Product Change Notification / SYST-23ZAVZ977

ERRATA - dsPIC33CH512MP508 Family Silicon Errata and Data Sheet Clarification

dsPIC33CH512MP508 Family Silicon Errata and Data Sheet Clarification

FIGURE 1-1: I/O RAMP

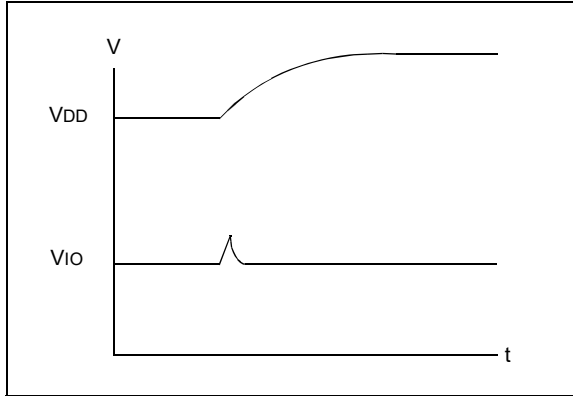
During a fast device power-up, when the VDD ramp is less than 4 mS, the I/O pins may drive up to 100 μ A current for a duration of up to 10 μ S (Figure 1-1).

Example applications affected may include complementary power switches, where a transient current shoot-through might occur. High-voltage applications with complementary switches should power the high-voltage 200 μ Sec later than powering the dsPIC[®] device to avoid the current shoot-through. This behavior is specific to each device and not affected by aging.

1. Slow down the VDD ramp time (greater than 4 mS for VDD to ramp 0V to 3.3V).
2. Ensure the circuitry that is connected to the pins can endure this pulse.

FIGURE 2-2: SUGGESTED PLACEMENT OF THE OSCILLATOR CIRCUIT

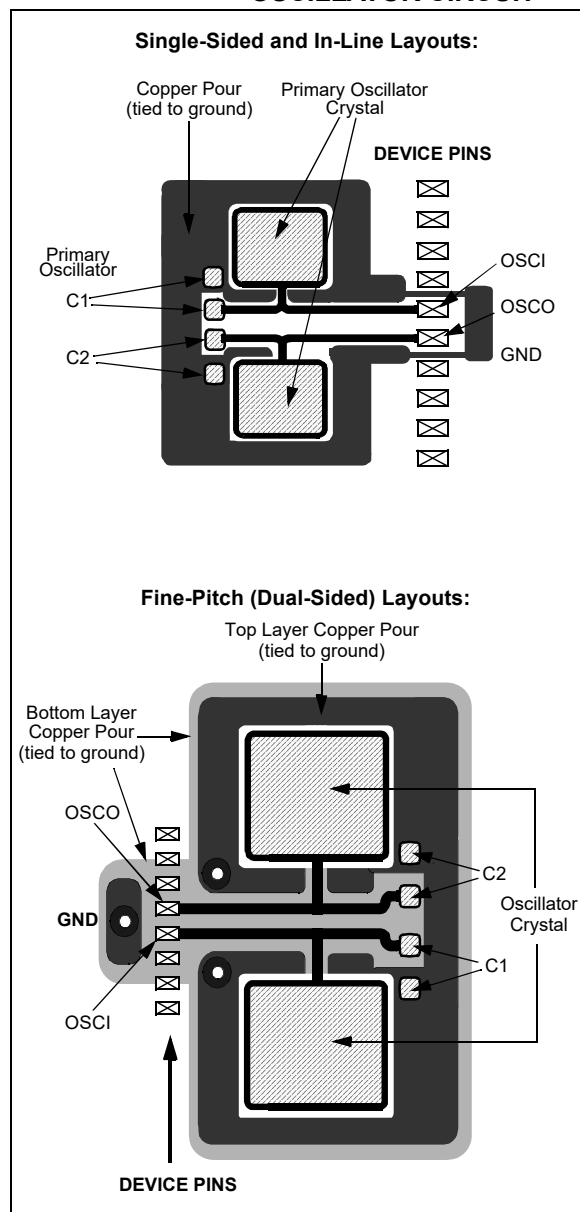
3. Module: Guidelines for Getting Started with 16-Bit Digital Signal Controllers

Additional information is added to [Section 2.5 “External Oscillator Pins”](#) and [Section 2.6 “External Oscillator Layout Guidance”](#) is added.

2.6 External Oscillator Layout Guidance

Use best practices during PCB layout to ensure robust start-up and operation. The oscillator circuit should be placed on the same side of the board as the device. Also, place the oscillator circuit close to the respective oscillator pins, not exceeding one-half inch (12 mm) distance between them. The load capacitors should be placed next to the oscillator itself, on the same side of the board. Use a grounded copper pour around the oscillator circuit to isolate it from surrounding circuits. The grounded copper pour should be routed directly to the MCU ground. Do not run any signal traces or power traces inside the ground pour. If using a two-sided board, avoid any traces on the other side of the board where the crystal is placed. Suggested layouts are shown in [Figure 2-2](#). With fine-pitch packages, it is not always possible to completely surround the pins and components. A suit-

able solution is to tie the broken guard sections to a mirrored ground layer. In all cases, the guard trace(s) must be returned to ground.
